Origination Form
Proposed Revisions to a Standard Plans Index

| Originator: | Gibbs, Shae | Index Number: | 711-003 |
| E-mail: | shae.gibbs@dot.state.fl.us | Index Title: | Interchange Markings |

TYPICAL INTERSECTION

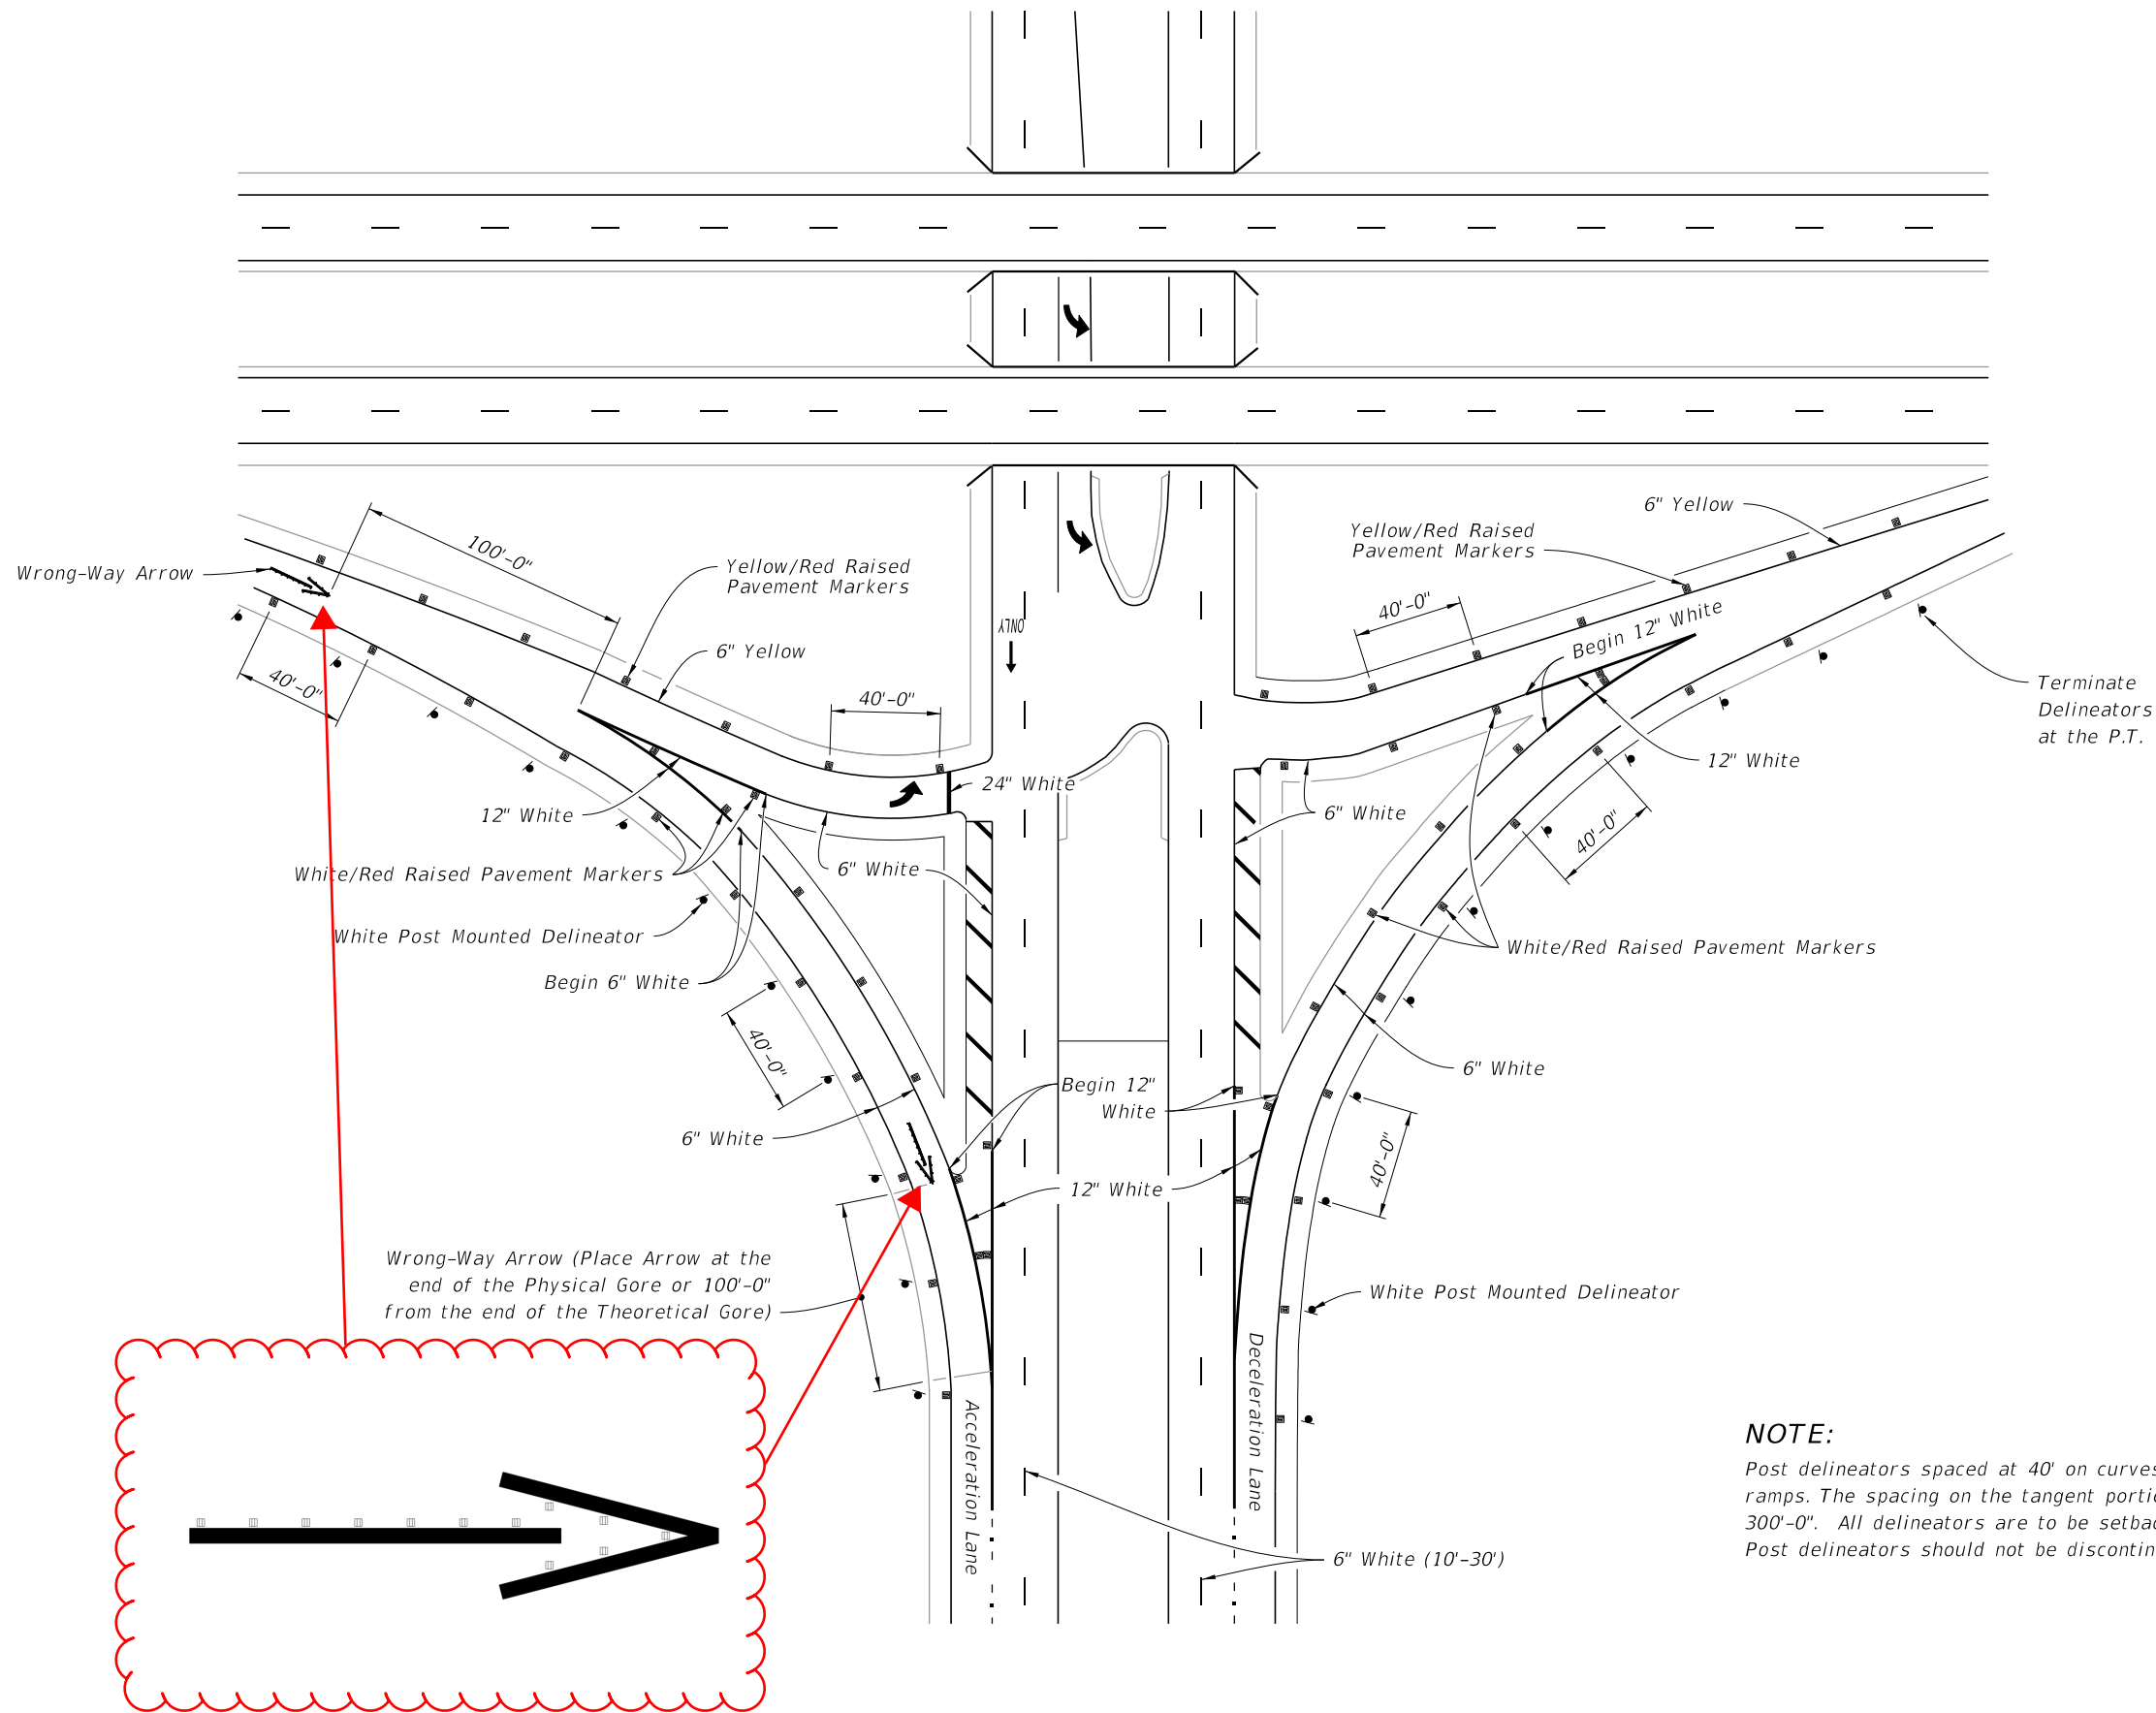
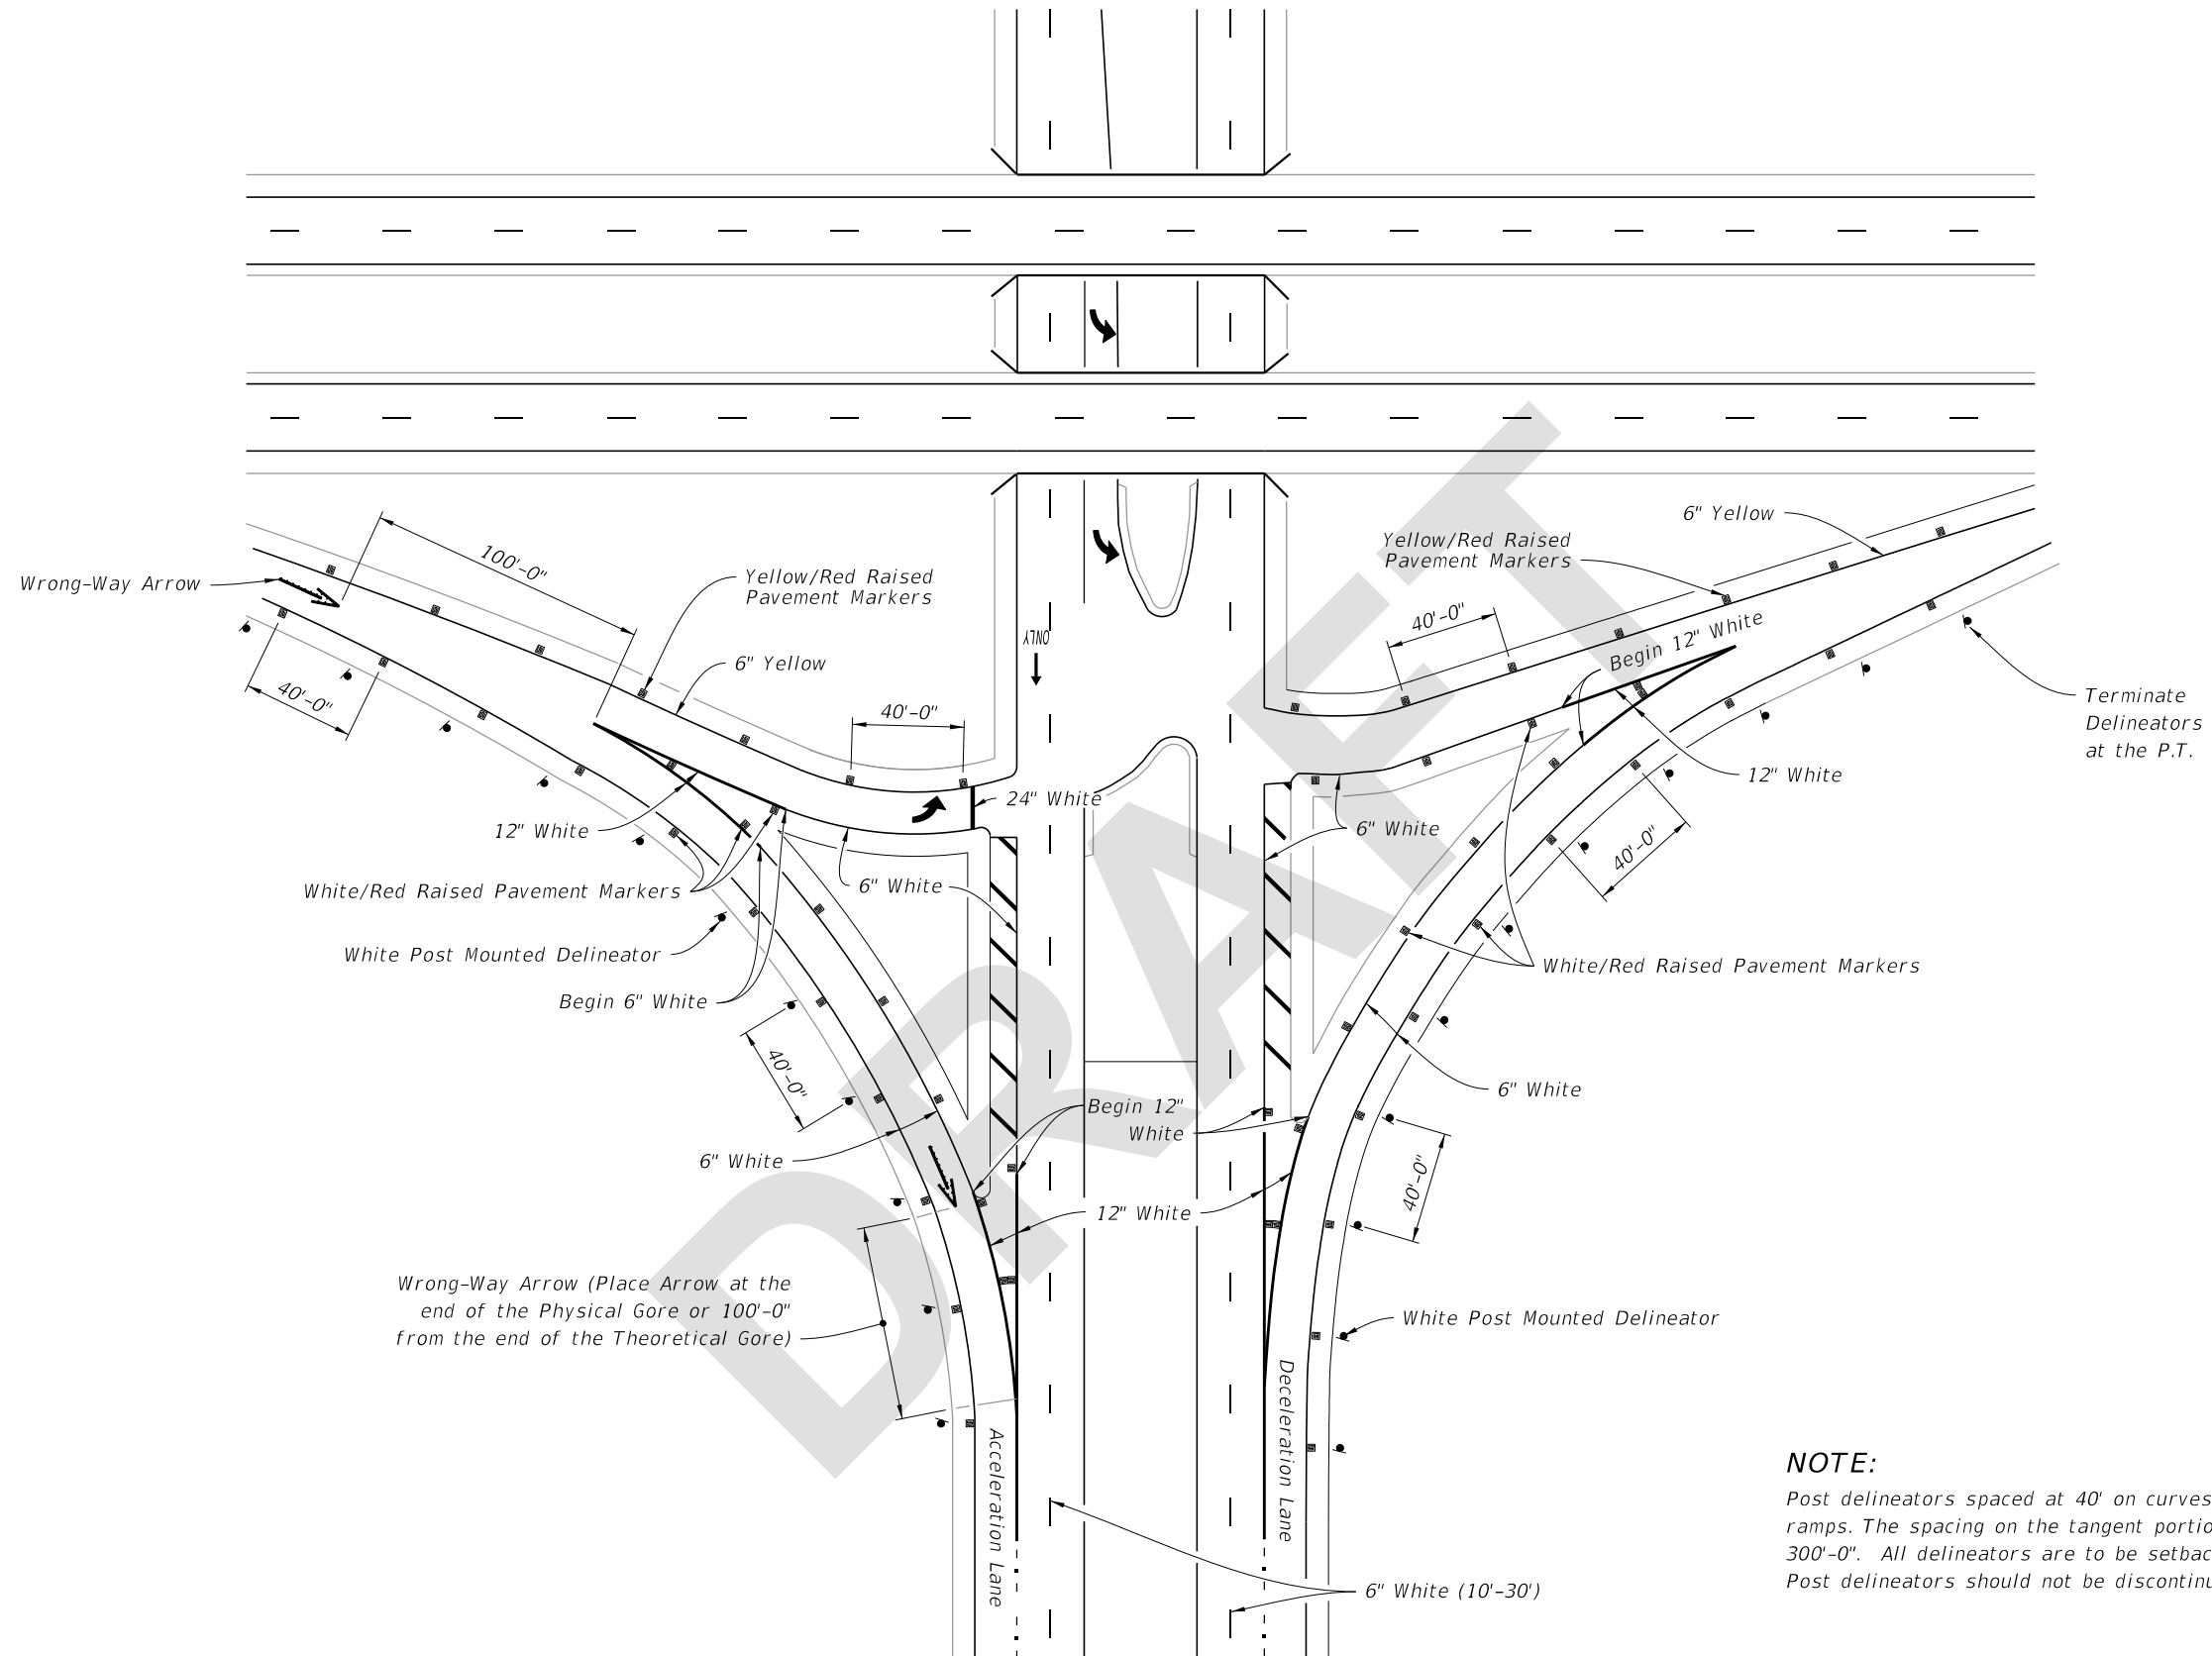
Sheets 5, 6, and 7: Update WWD Arrows to match proposed revision to 706-001

UPDATED Wrong Way Arrows to remove extra RPMs per 706-001 revision

TYPICAL PARTIAL CLOVERLEAF/TRUMPET EXIT RAMP

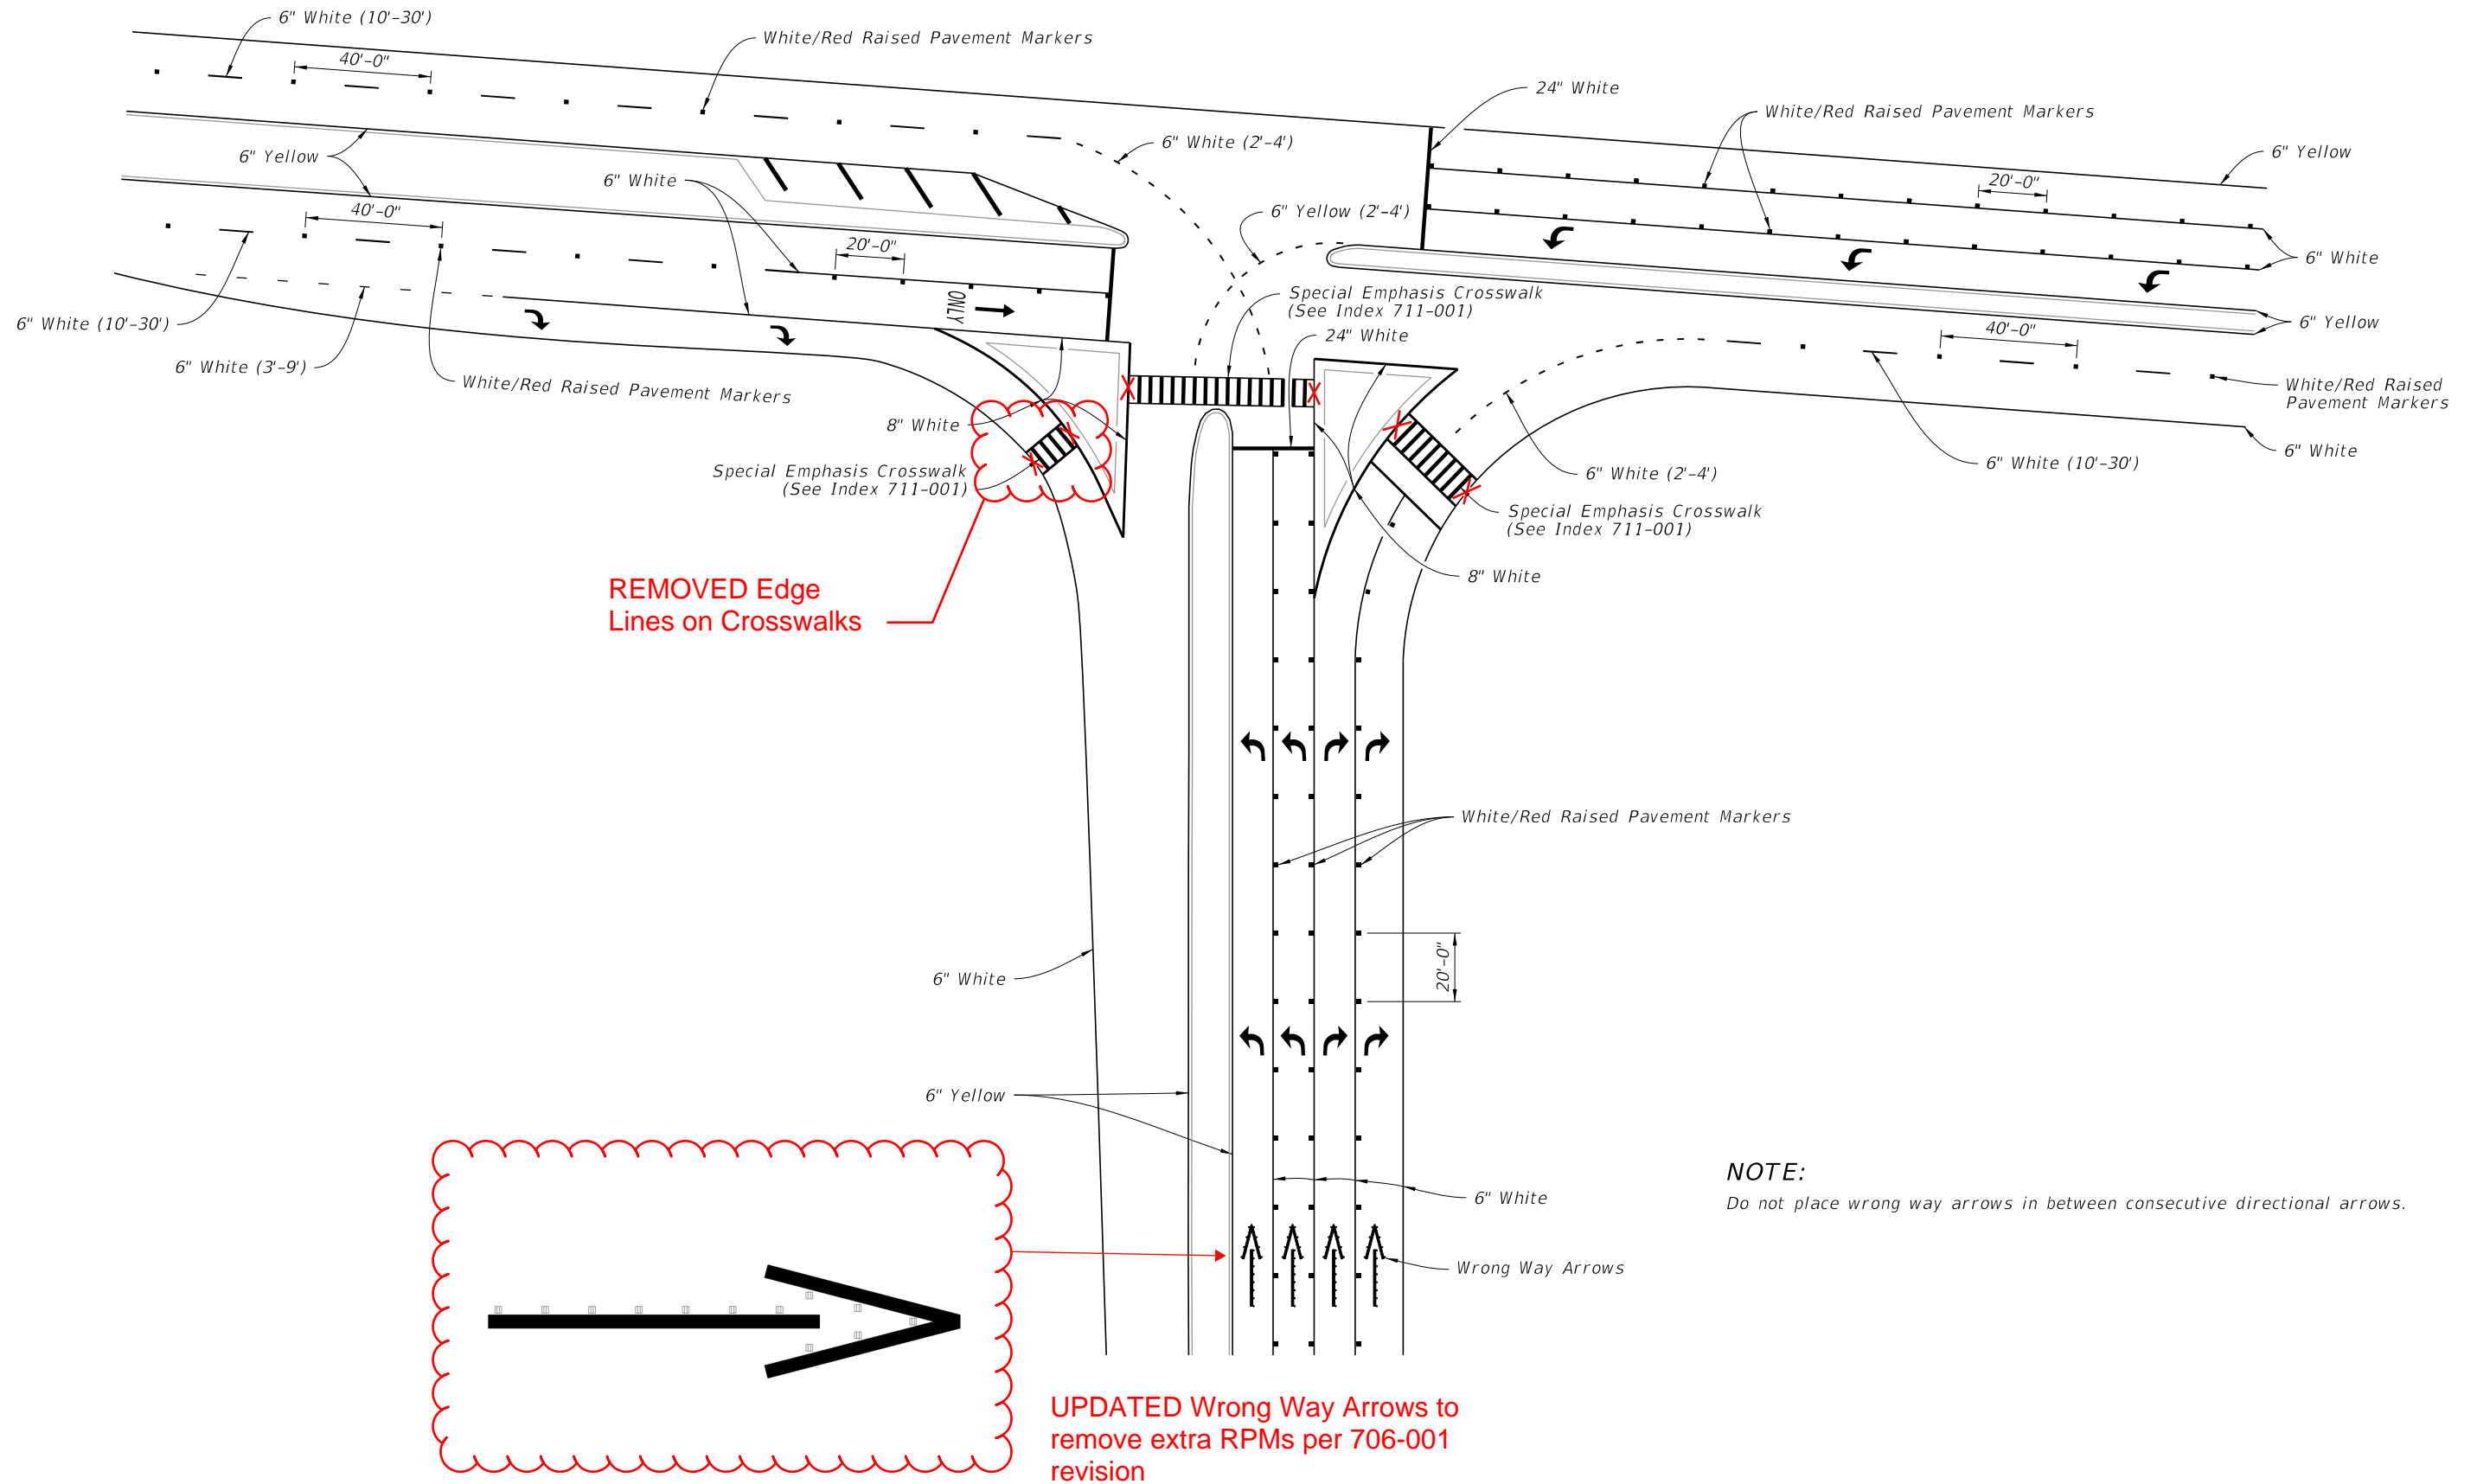
Sheet 2: Added SINGLE-LANE PARALLEL-TYPE ENTRANCE WITHOUT ADDED LANE detail.
Sheet 5: Updated wrong-way arrows to match 706-001.
Sheet 6: Updated wrong-way arrows to match 706-001.
Sheet 7: Updated wrong-way arrows to match 706-001, removed edge line markings from crosswalk areas.
